31/6-96J 10305 Armory Avenue
(Kensington Historic District)

HISTORIC PRESERVATION COMMISSION STAFF REPORT

Address: 10305 Armory Avenue Meeting Date: 6/26/96
Resource: Kensington Historic District Review: HAWP
Case Number: 31/6-96J Tax Credit: No
Public Notice: 6/12/96 Report Date: 6/19/96
Applicant: Richard Bond Staff: Genevieve Courbois
PROPOSAL: Add windows to rear facade **RECOMMEND:** Approval

PROPOSED CHANGES:

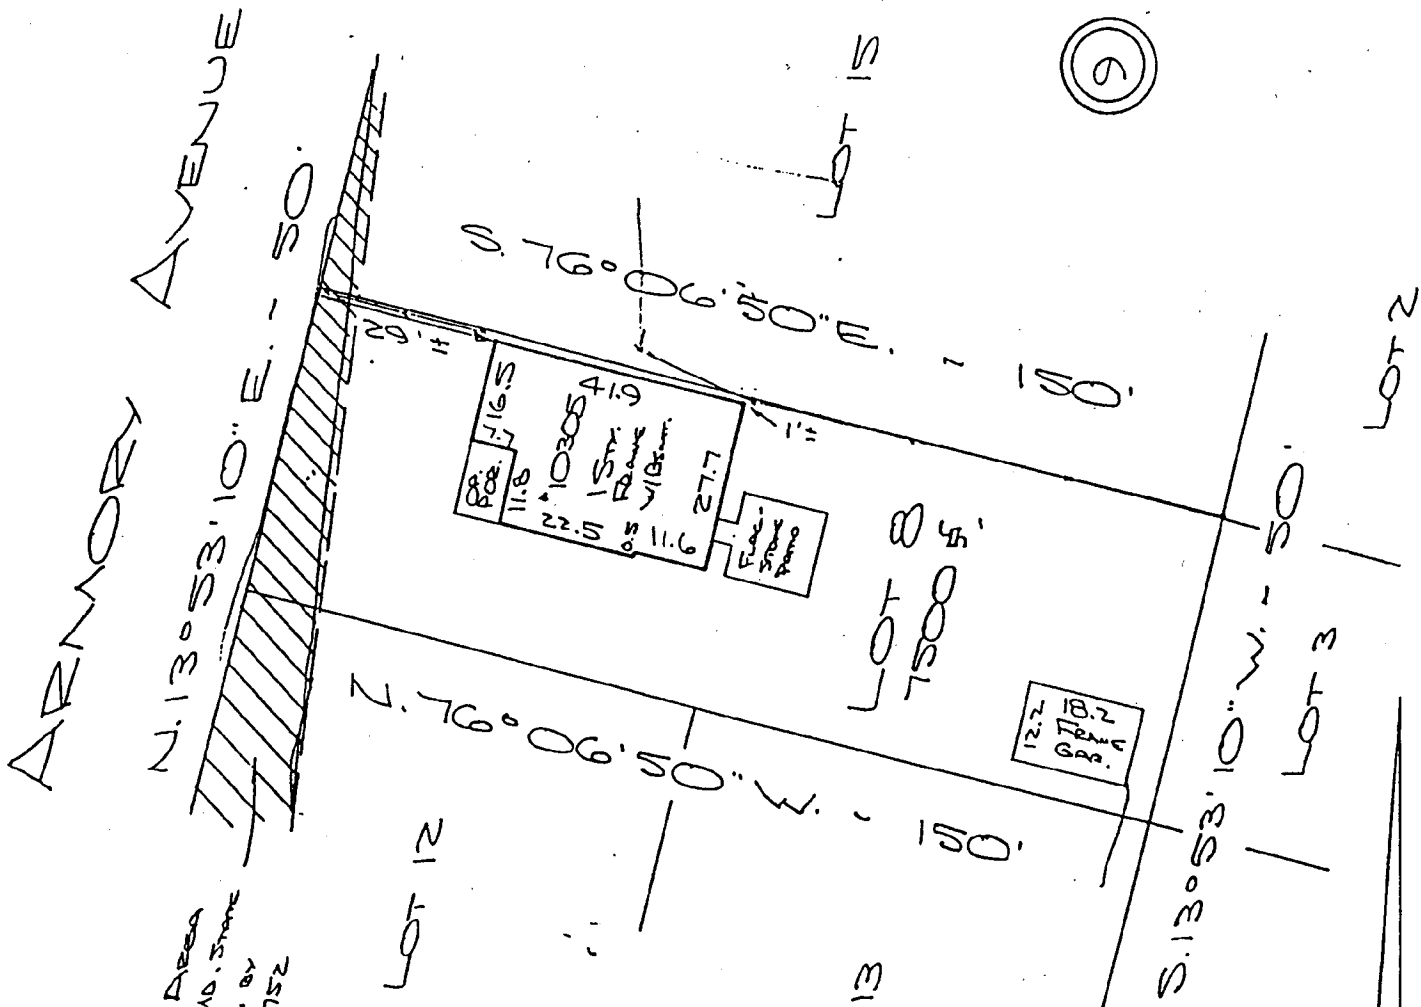
The applicant proposes to add three windows to the rear facade of the residence. A single-paned window measuring 28" x 26" will be placed directly above the rear door. Two 28" x 46" double-hung, six-over-one, thermal bar divided lite windows with applied muntins will be positioned on either side of the door. Detailing on these thermal bar divided lite windows includes 3/4" wide aluminum exterior muntins on the outer pane, 3/4" wide wood interior muntins on the inner pane and a 5/8" x 3/16" shadow bar between the two panes. The new windows will be aluminum clad wood windows and will each be framed with a 4" wide band of vinyl material to match existing windows in the rear facade.

One-over-one, double-hung windows are typical of this residence. Existing windows in the rear facade consist of two six-over-one, double-hung windows as well as one horizontal, band-like, four-lighted window.

The proposed windows are in keeping with the style and scale of the existing windows. In addition, alterations will be confined to the rear of the structure and therefore will not be visible from the public right-of-way.

Staff recommends approval of this application given the minimal exterior alteration, the existing features of the residence, and the location of the proposed alteration. Such alteration will not disrupt those qualities intrinsic to the district, "...the houses share a uniformity of scale, set backs and construction materials that contribute to the cohesiveness of the district's streetscapes. This uniformity, couple with the dominant design inherent in [the] original plan of subdivision, conveys a strong sense of both time and place that of Victorian garden suburb."

Maintaining the existing color scheme of the structure in any new trim or window sash is encouraged by the staff.
